**Subject: 2014 TSF Dam Raise Clearing and Borrow Material Access Road Construction**

Figure 1  
Plan of Operations Modification Request - TSF

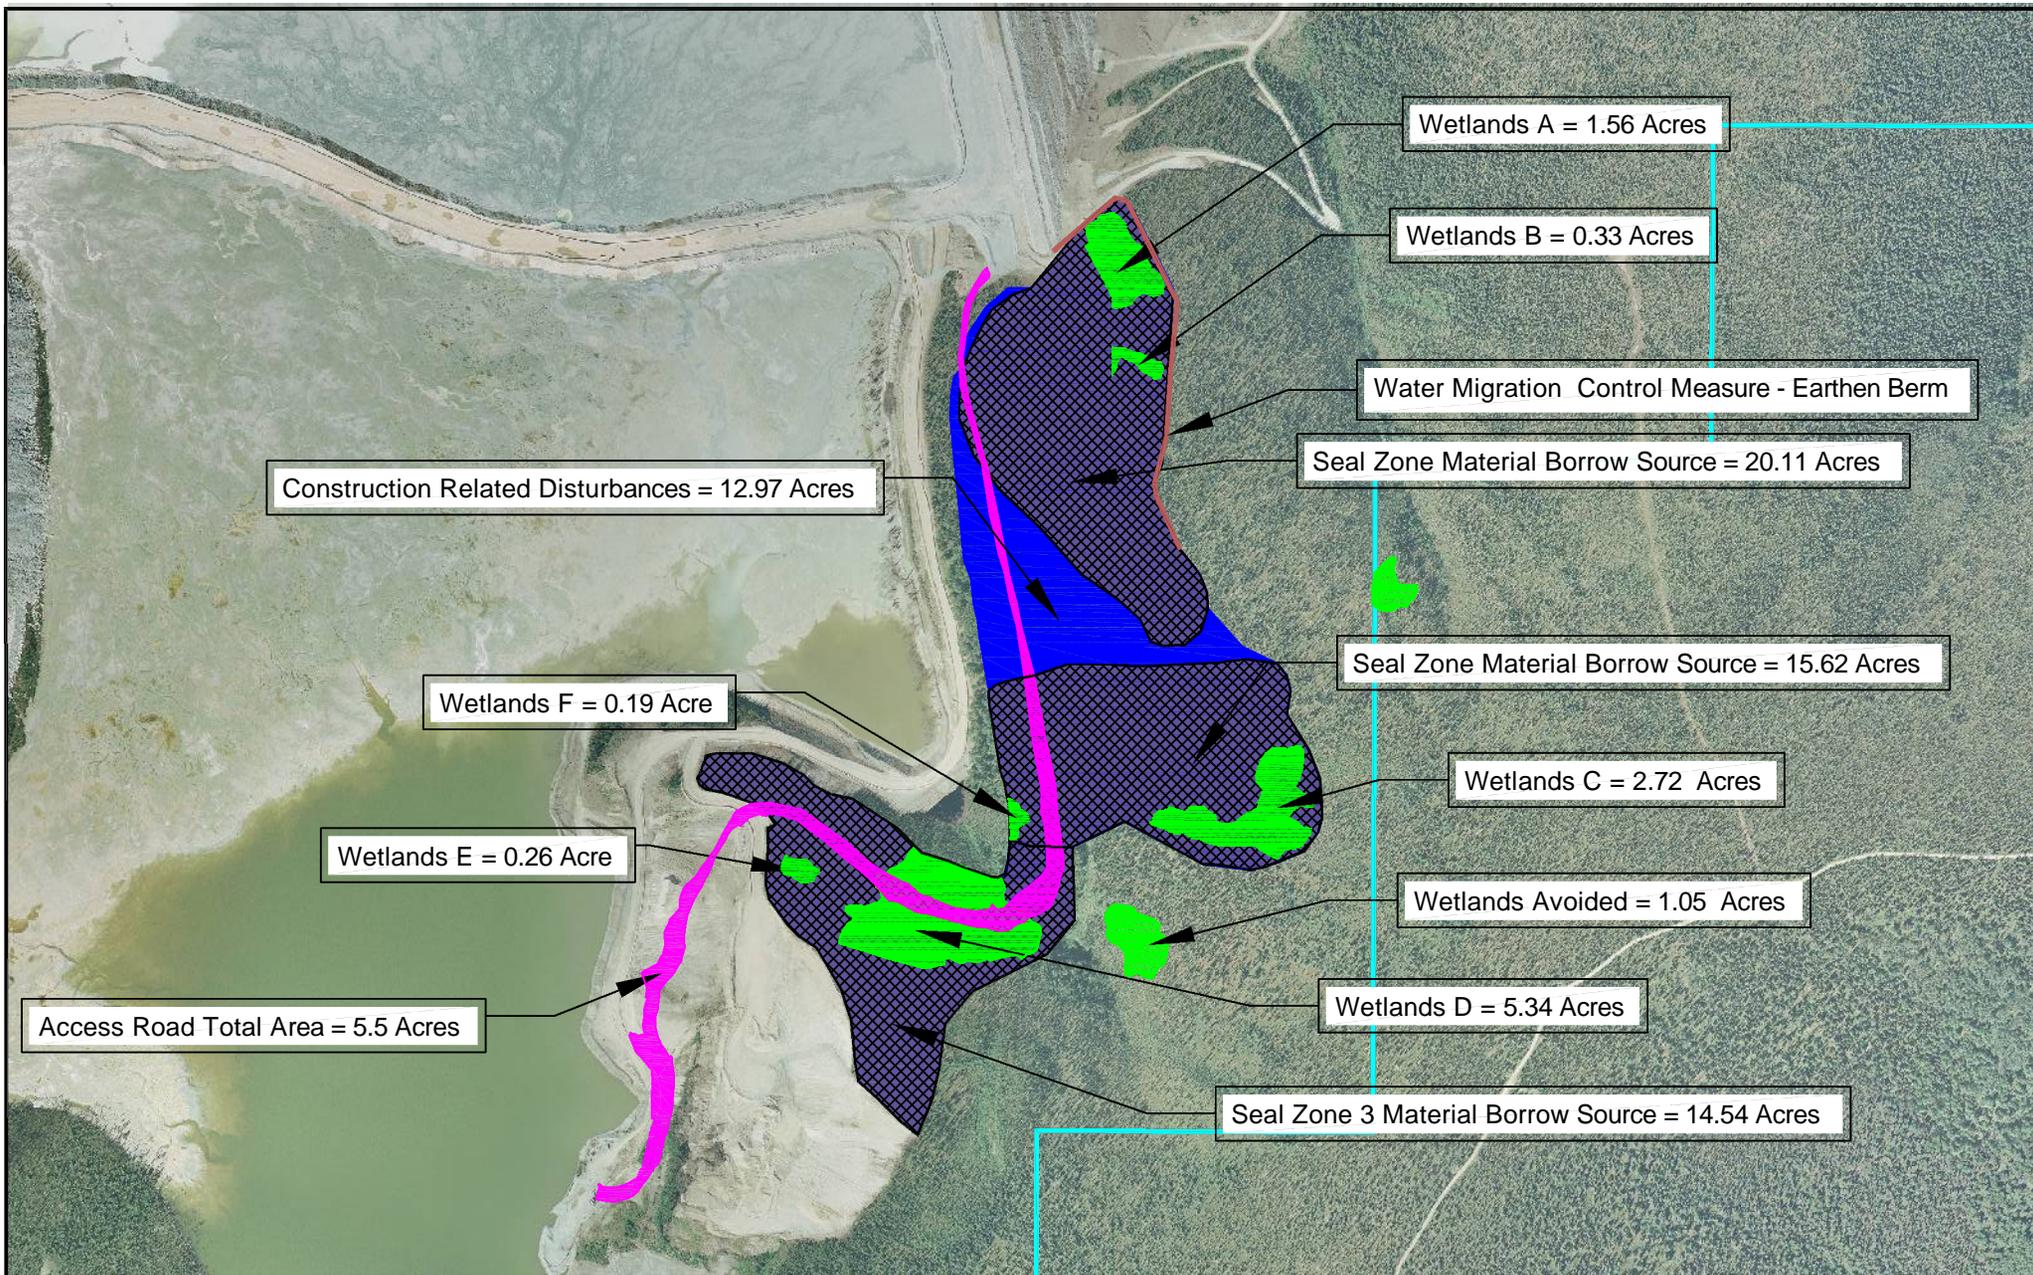
Fairbanks Gold Mining, Inc. (FGMI) is requesting a modification to our Plan of Operations for the Fort Knox gold Mine. The modification includes clearing 63 acres for the TSF dam raise filter and seal material borrow sources and the construction of a borrow material access road. The current decant waterline that transfers water between the South pond and Barge pond will be relocated to this access road.

The attached Figure 1 identifies the clearing limits for the borrow sources, the proposed access road and the current decant line.

To prevent water from migrating down below the tailings dam, the primary control measure will be to install earthen berms. Secondary control measures will be the installation of culverts and/or underdrains. The intent of this project is to divert water towards the TSF South pond. FGMI has the material on site to implement these control measures.

Wetlands were identified in the area of this proposed disturbance and are shown on Figure 1. An application to the US Army Corps of Engineers has been submitted.
